RE: Calico Solar (formerly Solar One) Project (08-AFC-13)
Applicant's Submittal of Alternative Site Layout #2, Engineering Figure with SunCatcher Layout,
and Revised Project Boundary with 4000' Desert Tortoise Corridor Figure

Tessera Solar hereby submits the Applicant's Alternative Site Layout #2, Engineering Figure with SunCatcher Layout, and Revised Project Boundary with 4000' Desert Tortoise Corridor Figure.

ALTERNATIVE #2 PROJECT LAYOUT
TOTAL PROJECT: 6215 ACRES
CALICO SOLAR

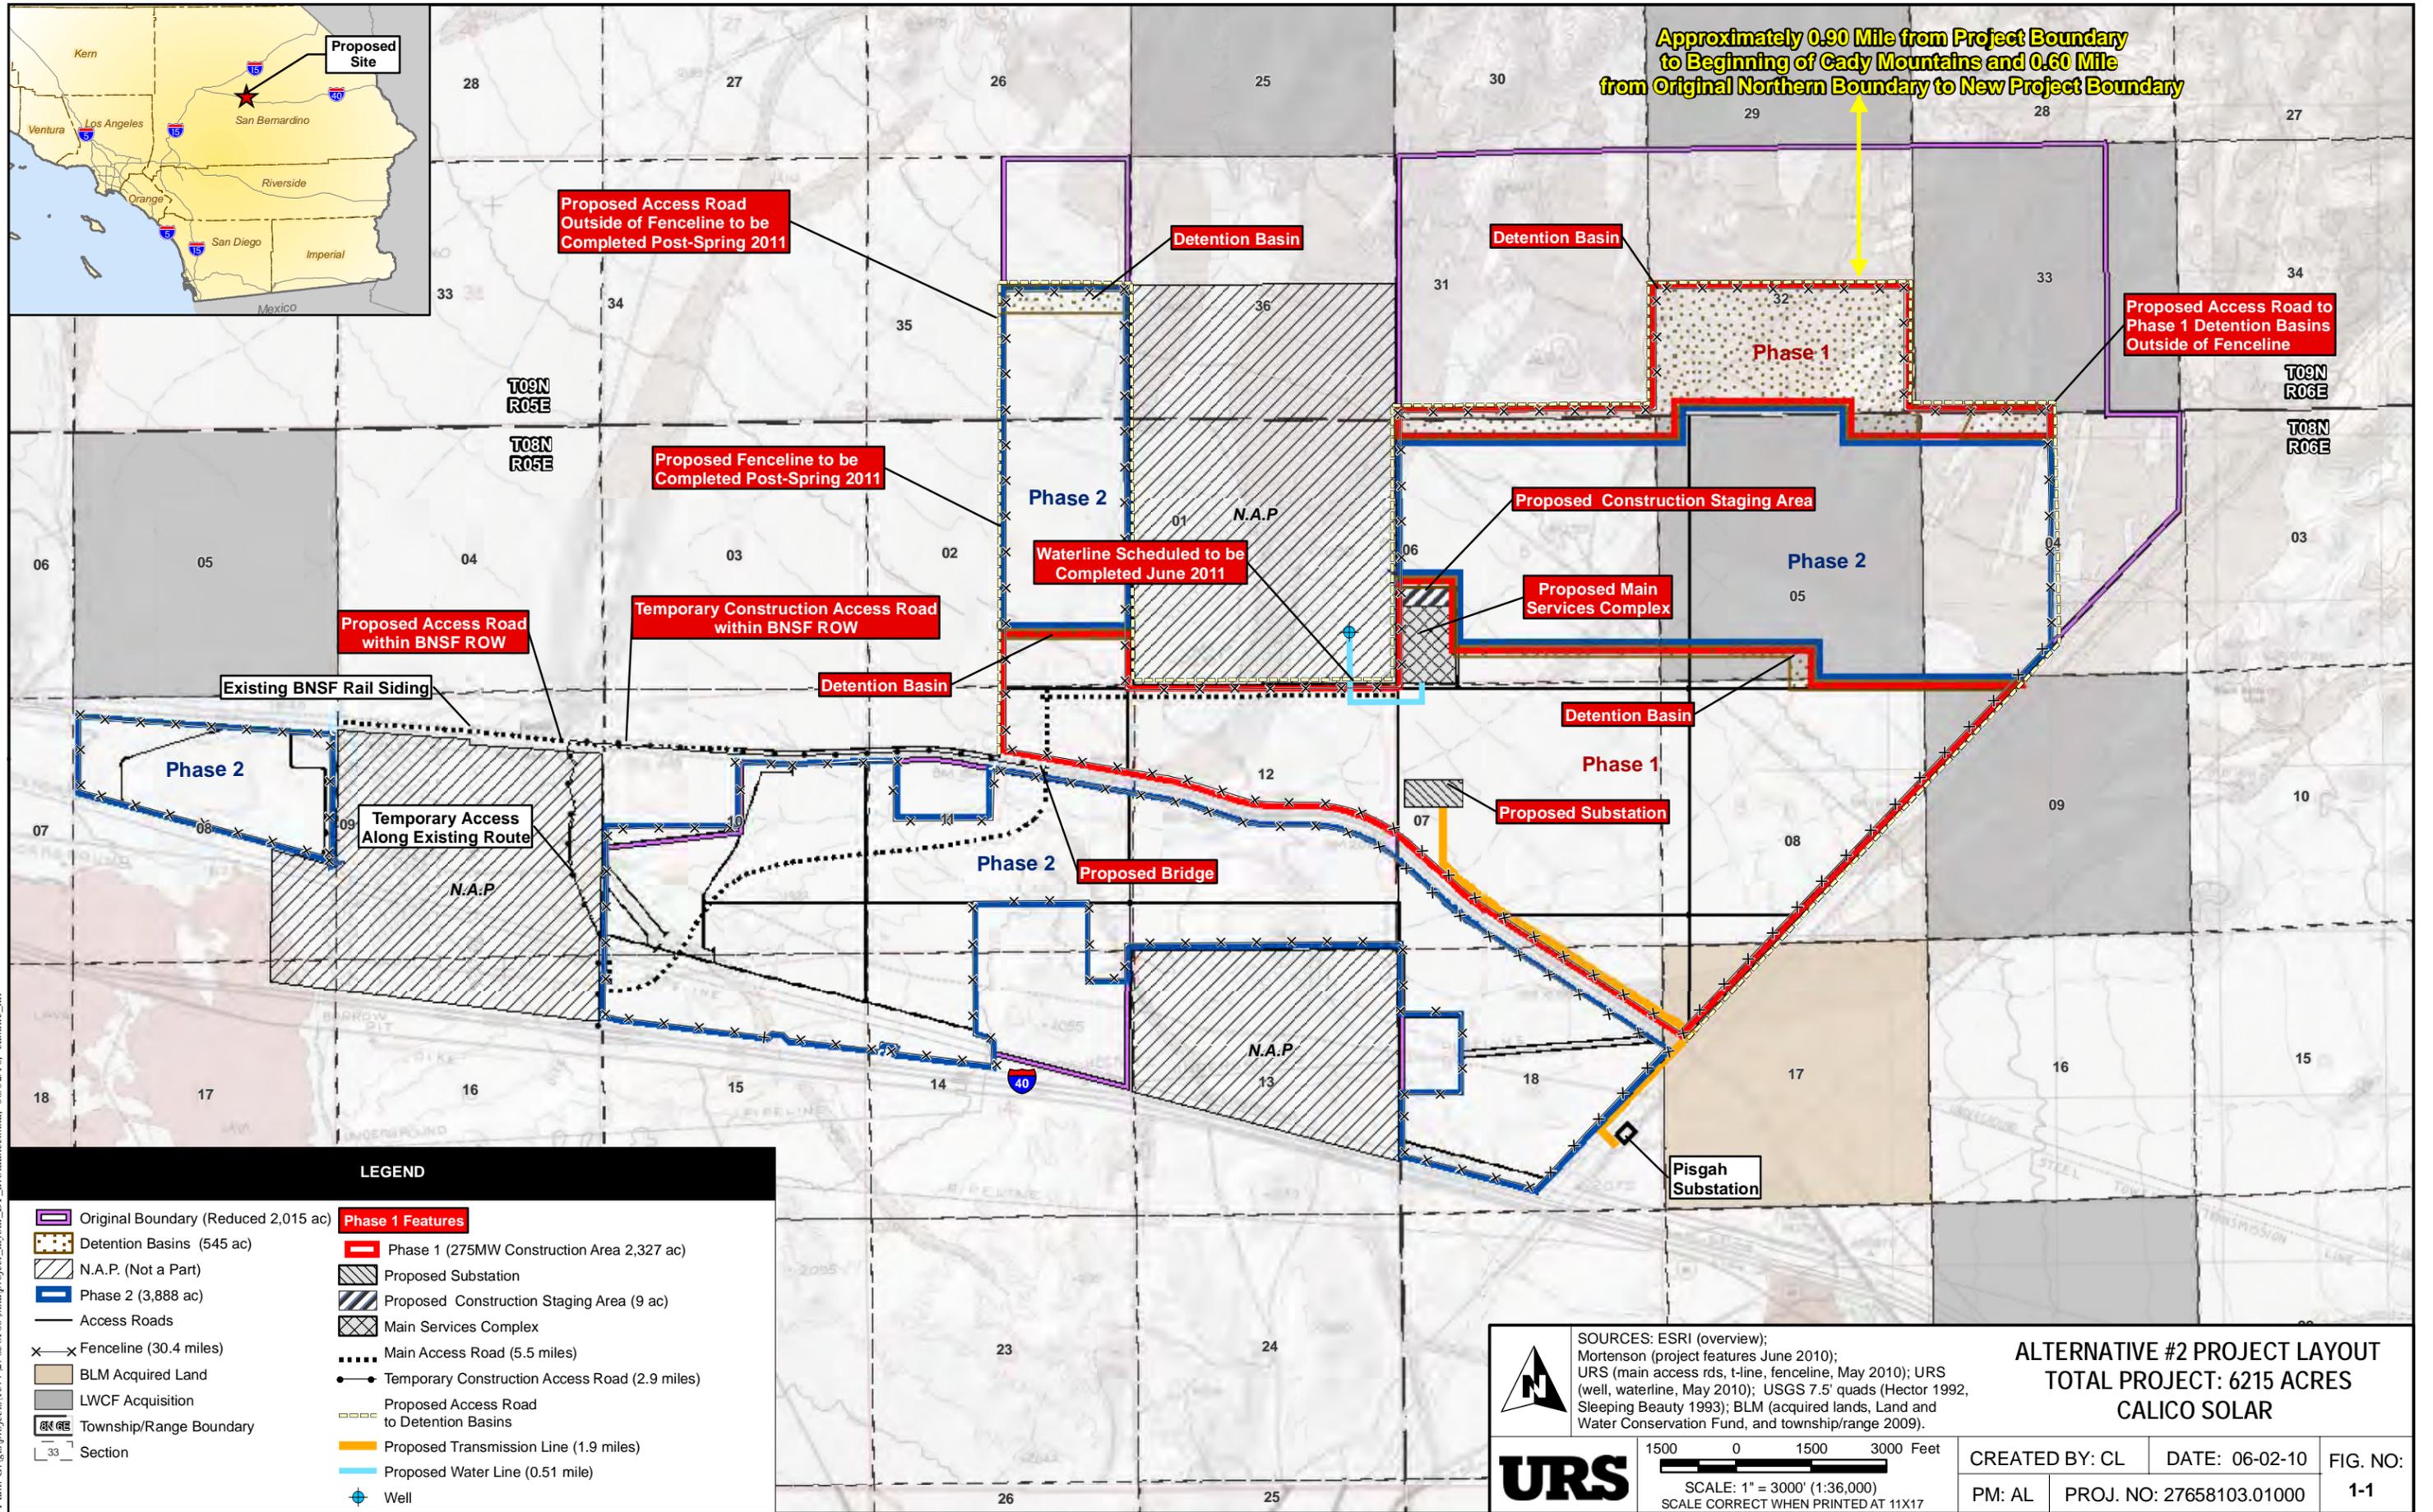
On May 14, 2010 a Supplement was filed that described modifications to the Project's northern boundary. Based on input from the U.S. Fish and Wildlife Service's Desert Tortoise Recovery Office (DTRO) and the Bureau of Land Management (BLM), the northern boundary of the Project site has been further modified to include a 4,000-foot wildlife corridor between the Project (inclusive of all detention basins) and the base of the Cady Mountains. To accommodate this modification, the detention basins were re-configured to extend east to west along the northern Project boundary and the boundary between Phases 1 and 2. Through this change in detention basin design, two objectives are achieved: the detention basins are included within the Project fenceline and outside of the 4,000-foot wildlife corridor, as requested by the wildlife agencies, and the detention basin design maintains the natural drainage patterns of the site.

The modified northern Project boundary avoids many of the detected sensitive plant species, as discussed in the Applicant's Submittal of First Round Spring Botany Survey Results. Additionally, the attached current engineering of the SunCatcher layout avoids Environmentally Sensitive Areas (ESAs) south of the railroad and within the Project boundary. The ESAs avoided within the Project boundary include all detected occurrences of white-margined beardtongue.

As noted in the Applicant's comments on the Staff Assessment/Draft Environmental Impact Statement (SA/DEIS), the original 8,230-acre Project area was requested for the build out of an 850 MW Project, recognizing that some acreage would likely be ceded to allow for building around sensitive species and cultural areas, where practicable. Compared to the avoidance of the donated lands alternative that would create avoided areas that would be surrounded by the solar project, the Alternative Site Layout #2 provides for a wildlife corridor adjacent to existing open areas. Alternative Site Layout #2 can accommodate the development of 850 MW, allowing the Applicant to meet the conditions of the Power Purchase Agreement (PPA). As further explanation of that, below is the information filed in Calico Solar's recent status report:

Figure 19 -
 Site Plan

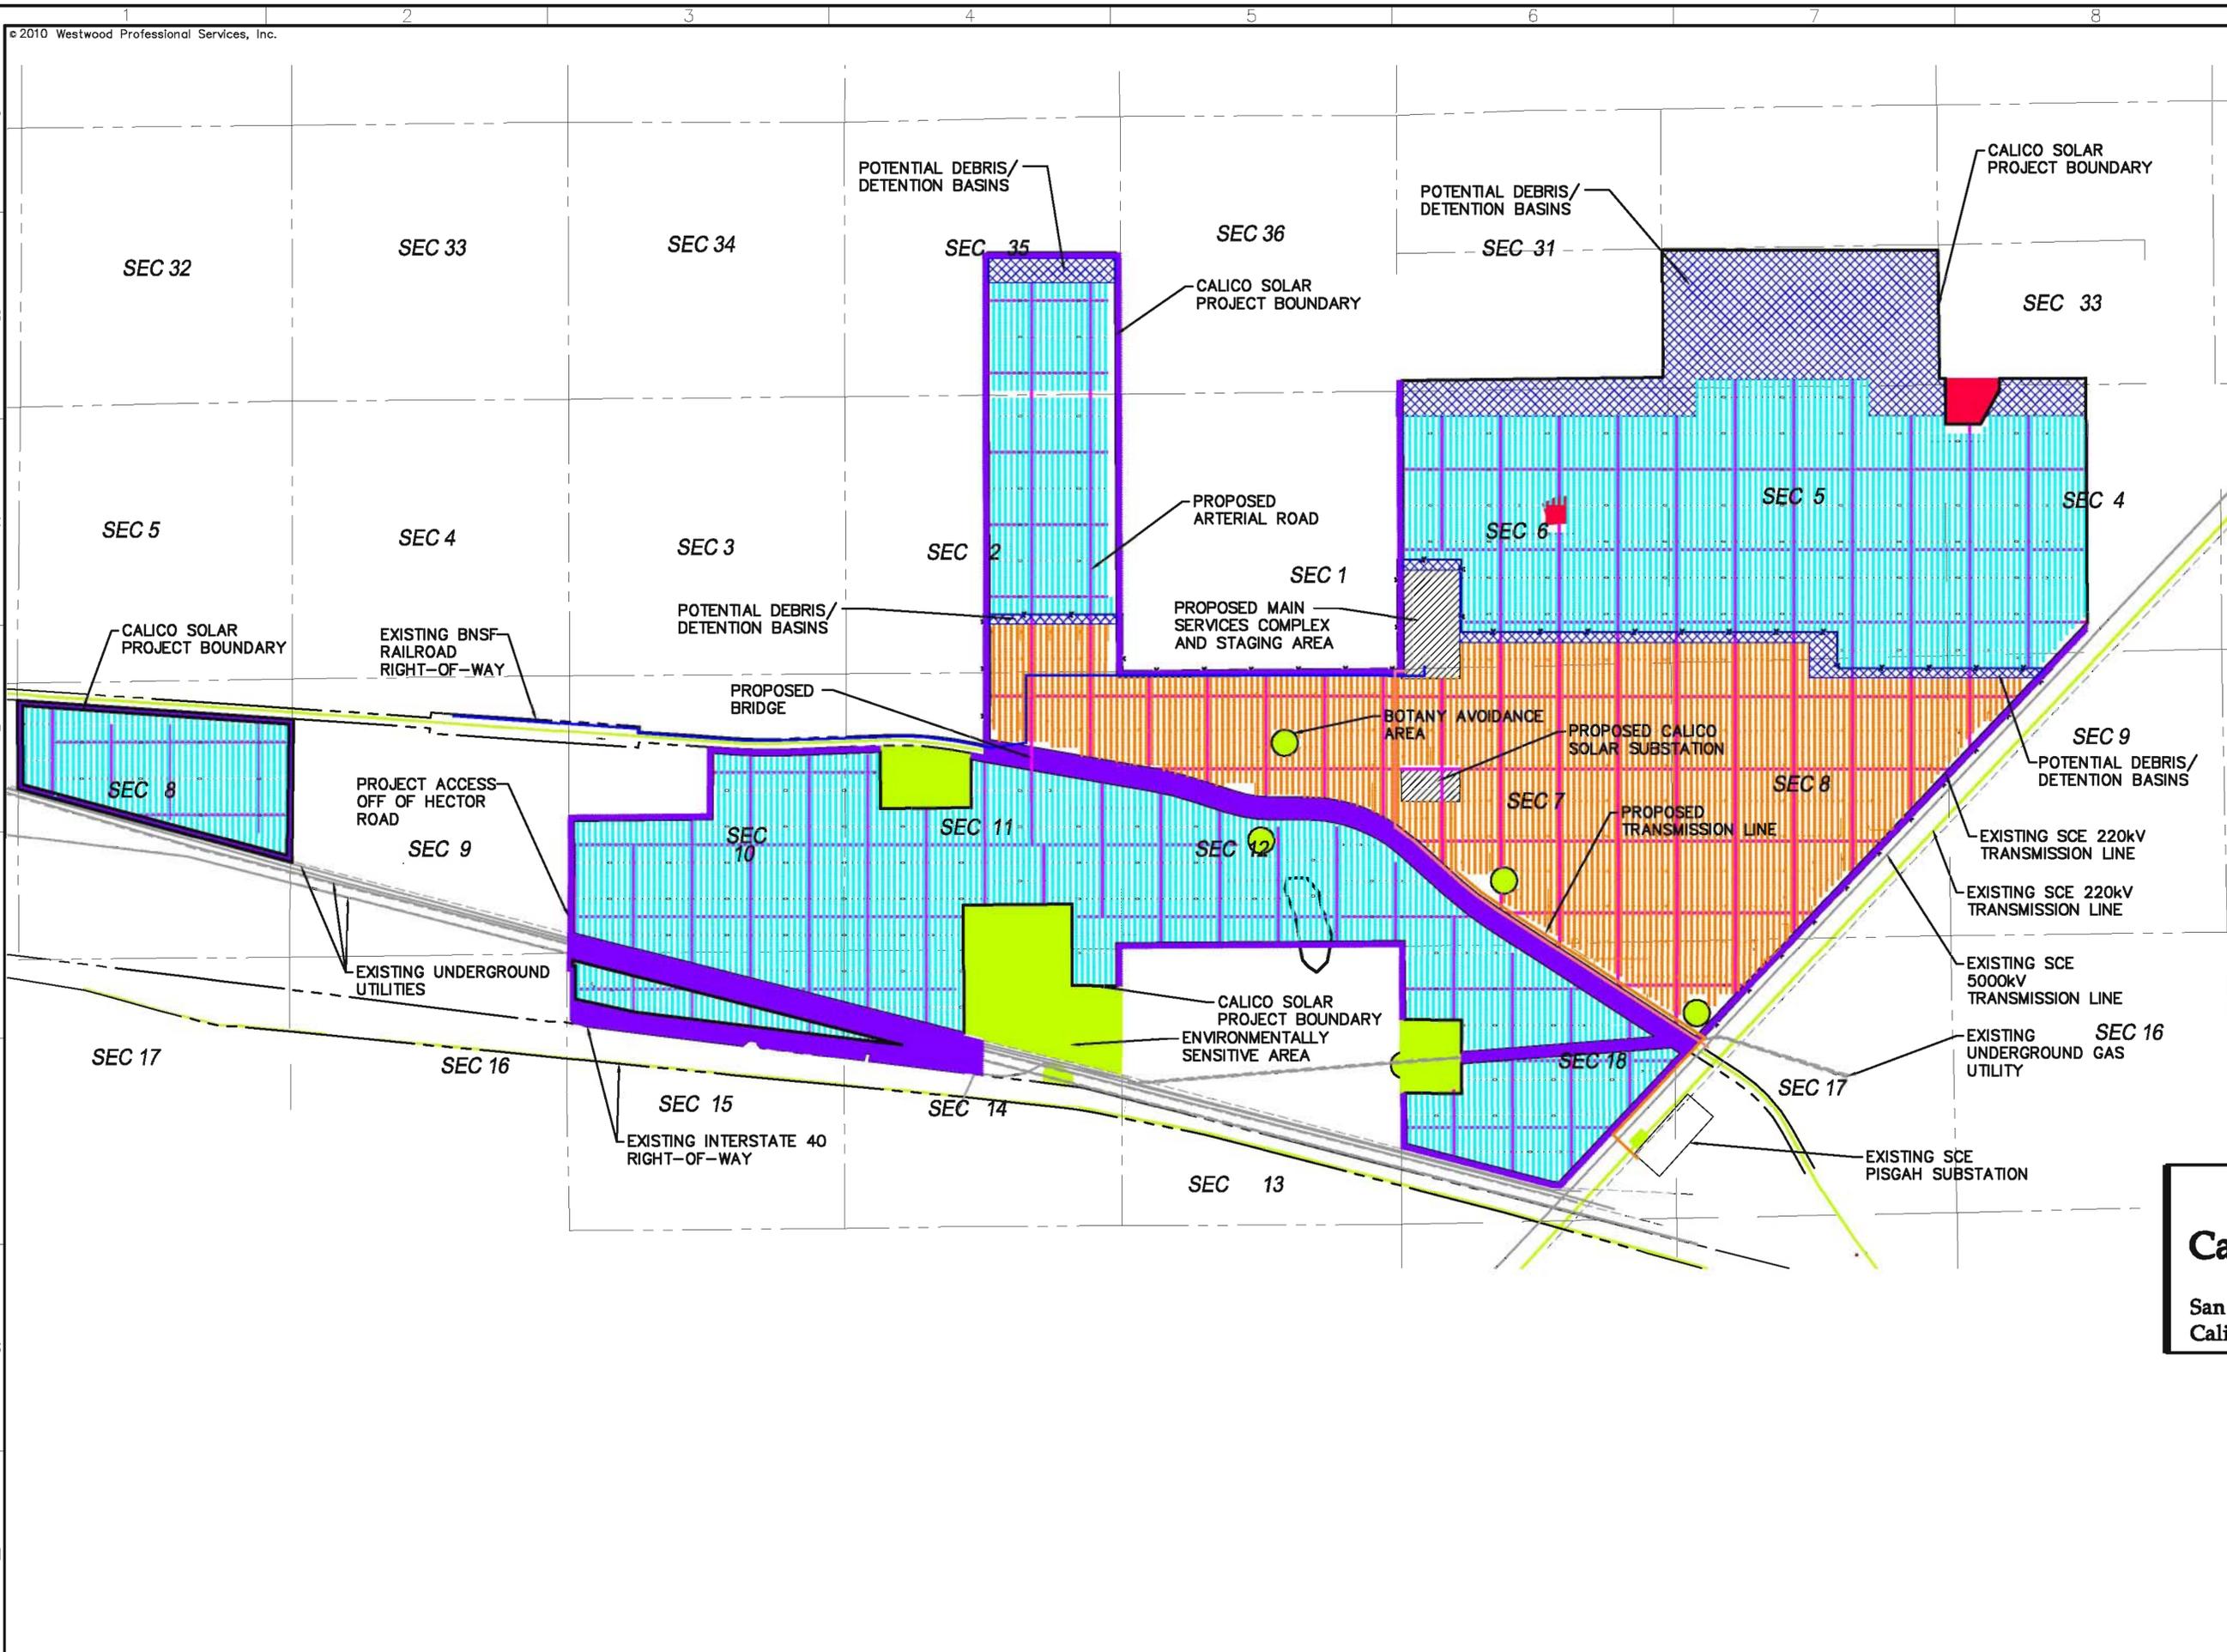
The Engineering Figure with the SunCatcher layout shows that the Applicant is able to focus development of SunCatchers and support facilities on a smaller footprint and achieve the same level of generation. This will allow the Applicant to meet the requirements of the PPA, avoid environmentally sensitive areas, reduce the loss of desert tortoise, avoid or reduce special status plants as well as pull down from the toe of the Cady Mountains as indicated. It will make construction somewhat more costly, though, given that space for lay-down and movement is more restricted. It should be noted, however, that the spacing between the SunCatchers is not being changed whatsoever.
